**HISTORIC PRESERVATION REVIEW BOARD
STAFF REPORT AND RECOMMENDATION**

| Property Address: | 2001 18th Street NW | X | Agenda |
| Landmark/District: | Washington Heights Historic District | | Consent Calendar |
| H.P.A. Number: | 22-227 | | Permit Review |

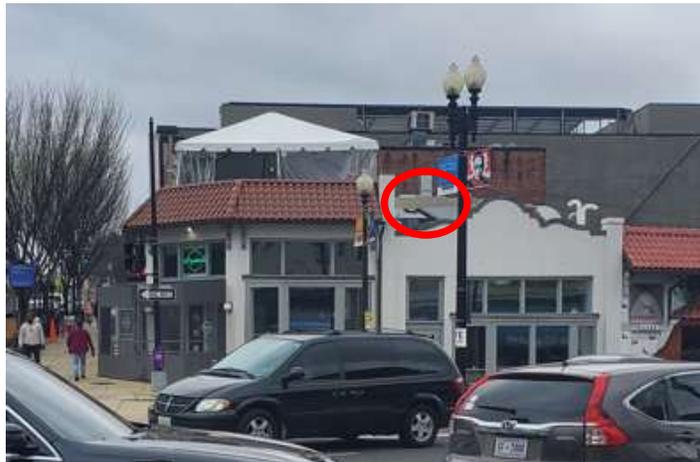
Also unpermitted is a fabric exterior vestibule and handrail at the corner entrance, for which the owner seeks after-the-fact approval. The railing lines the at-grade corner entrance, which steps down from 18th toward U Street. The enclosure is a metal framed structure with fabric walls and roof and large transparent vinyl “windows.”

The front entry enclosure is also not compatible with the building's form and the streetscapes of the Washington Height Historic District. The bulky, boxy addition reads as an addition to the front of the building and blocks the view of the corner entry and its architectural features. Its scale, materials, and location are incompatible with the historic building and district. The staff has no objection to the railing that was installed, which can be seen inside the enclosure, and recommends support for the Public Space application that is necessary for it to remain.

The HPO recommends that the Board deny the concept of a rooftop structure and exterior vestibule enclosure as inconsistent with the Act and incompatible with the character of the historic district. HPO further recommends that the Board direct the applicant to remove the unpermitted roof tent and delegate permit approval for the installed railing to staff.
